REVISION	DATE	DESCRIPTION	BY
3	Jul 90	As built - No change	D.S.
4	13 May 88	Added Interceptor Ditch No. 1	T.D.
DEPARTMENT OF THE ARMY NEW YORK DISTRICT, CORPS OF ENGINEERS NEW YORK, NEW YORK			
DRAWN BY: <i>EJM</i>		SAW MILL RIVER, NEW YORK	
CHECKED BY: <i>D.S.</i>		ARDSLEY FLOOD CONTROL PROJECT	
DESIGNED BY: <i>Thomas J. ...</i>		MAIN CHANNEL PROFILE	
REVIEWED BY: <i>James ...</i>		ARDSLEY	
SUBMITTED: <i>C. ...</i>		RECOMMENDED: <i>Stanley ...</i>	
APPROVED: <i>W. ...</i>		SCALE AS SHOWN	
DATE: 20 JULY 1987		DRAWING NUMBER: CC-ARD-411	
		SHEET 11 OF 48

Designed by: 	SAW MILL RIVER, NEW YORK
Drawn by: EJM	ARDSLEY FLOOD CONTROL PROJECT
Checked by: D.S.	PROFILES-INTERCEPTOR
	DITCHES NO. 1 & 2
Reviewed by: 	ARDSLEY CHIEF, ENGINEERING DIVISION
Approved by: 	Sheet reference number: CC-ARD-413
Concurred by: 	Date: 20 JULY 1987
ASST. CHIEF, DESIGN BRANCH	Scale: AS SHOWN
	Sheet 13 of 44

SAW MILL RIVER, NEW YORK
ARDSLEY FLOOD CONTROL PROJECT
CROSS SECTIONS—STA 0+27U TO STA 8+02U

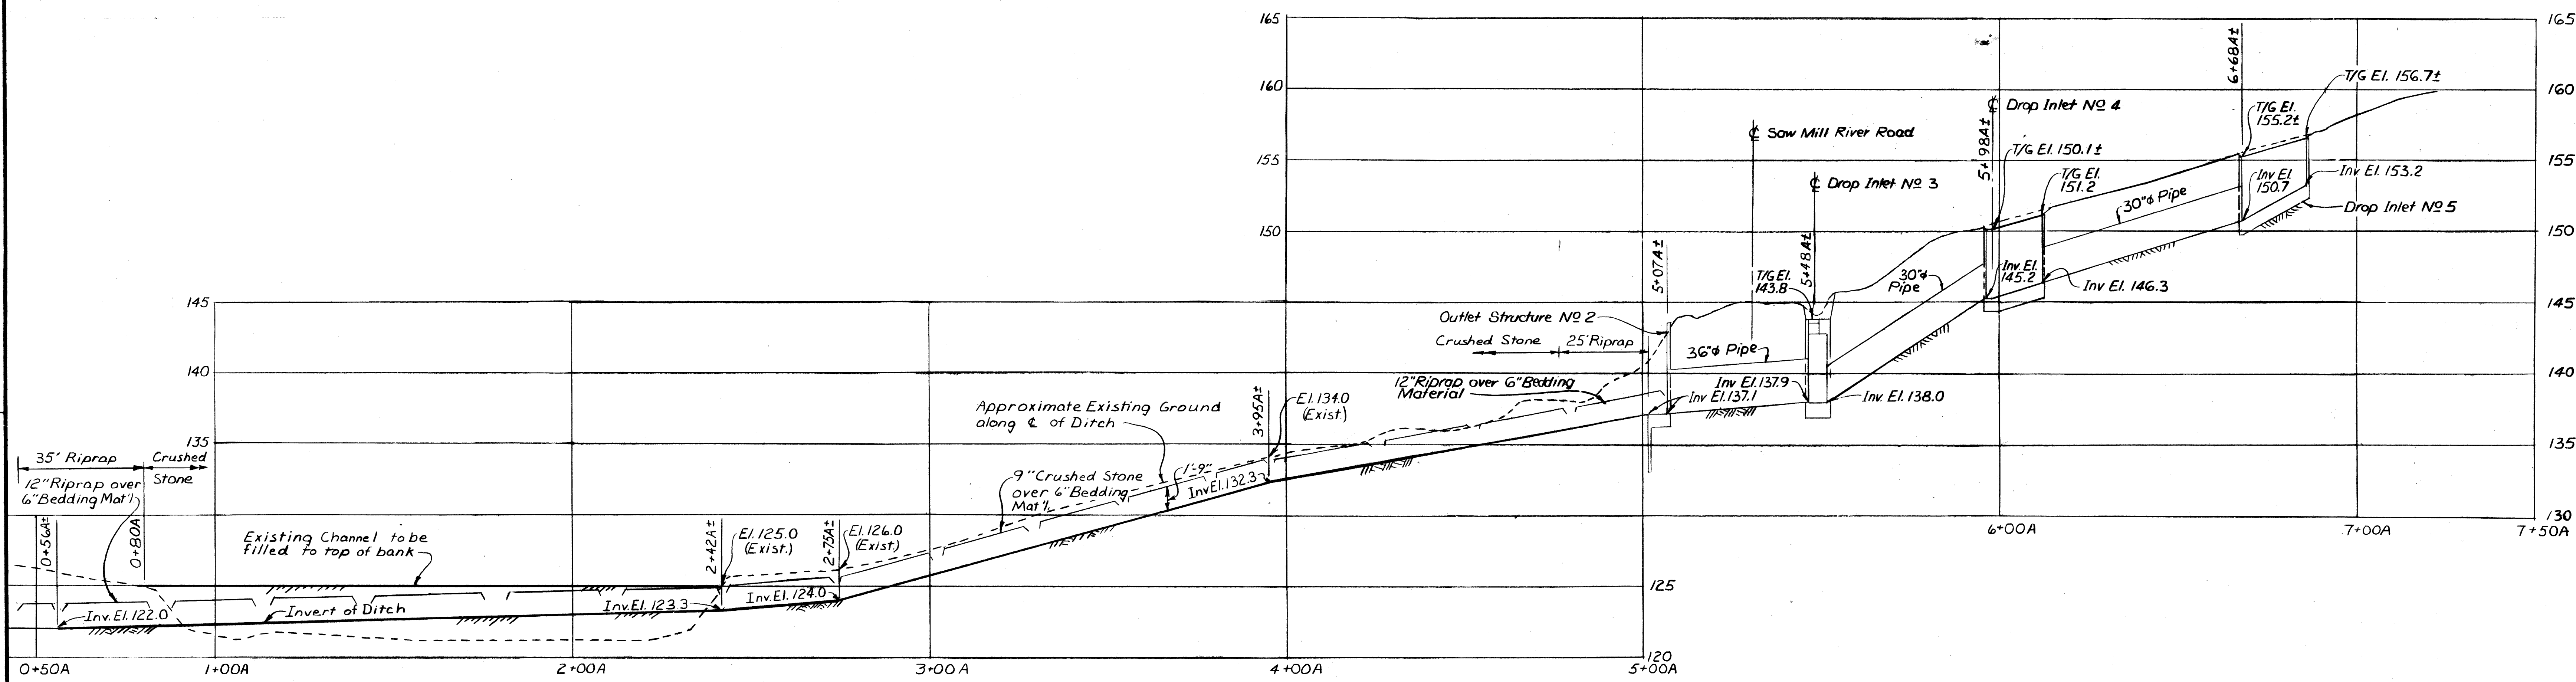
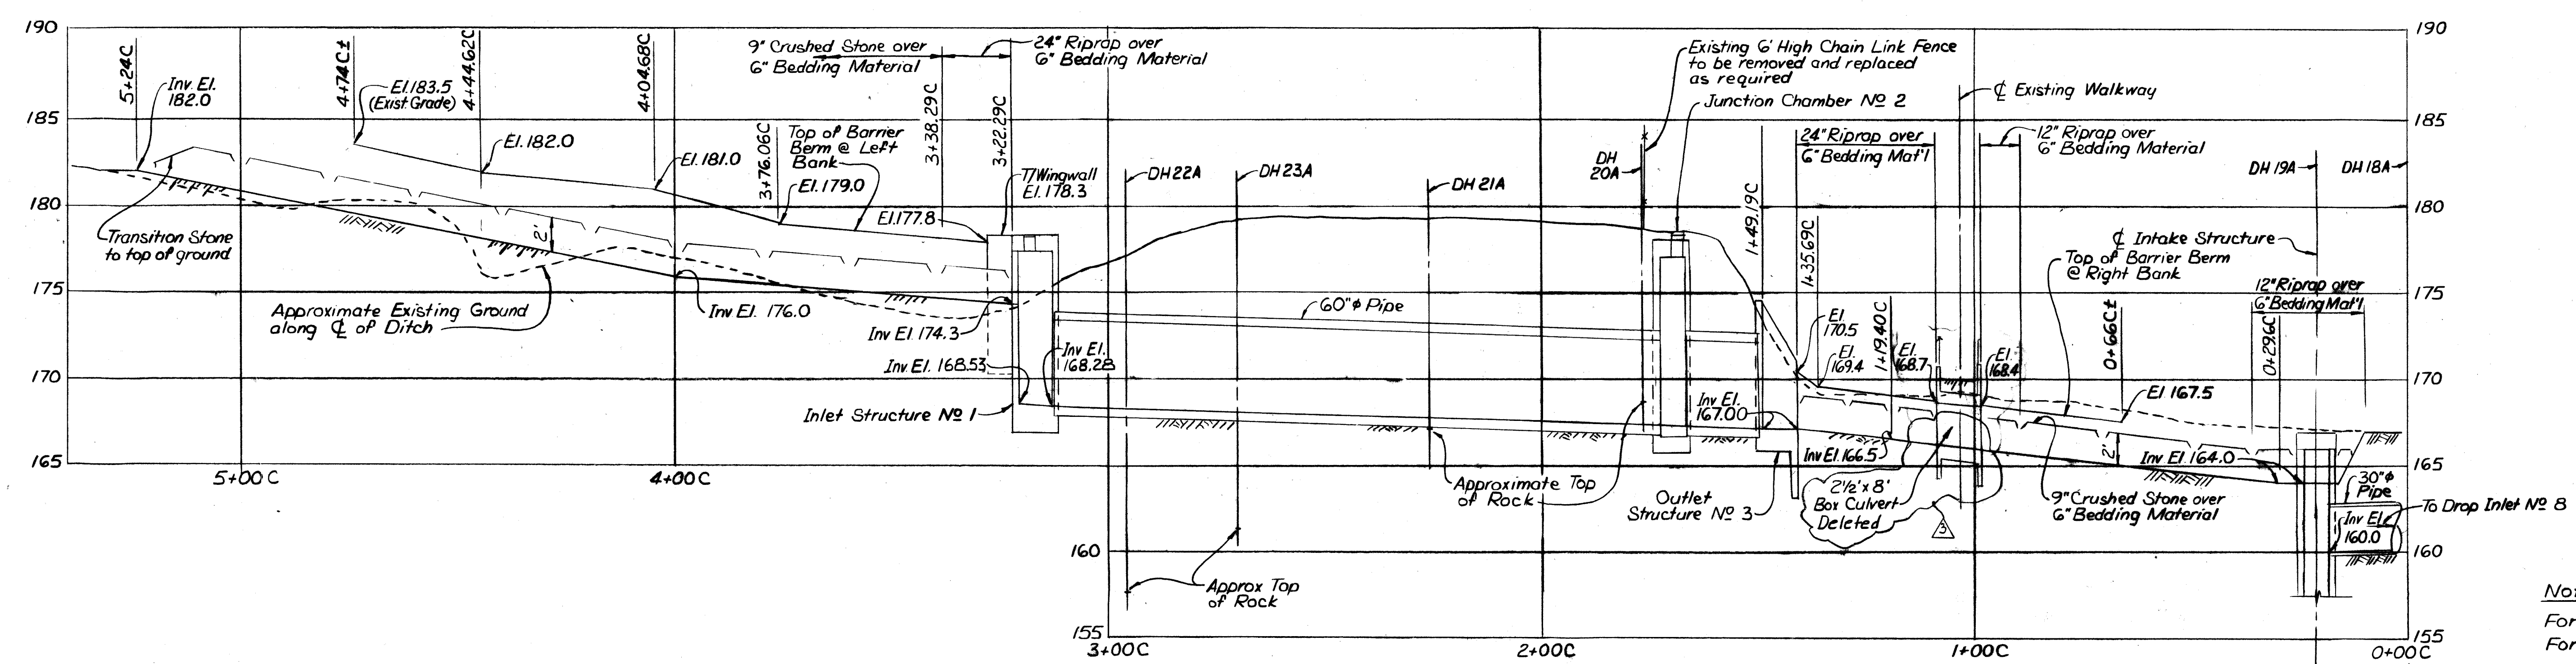
24"x6" Box CULVERT DELETED - as built	31 JUL 90	O.P.
	Revised Interceptor Ditch No 2	5 May 89	T.D.
	Revised Interceptor Ditch No 1	13 May 88	T.D.
Revision	Description	Date	Approved
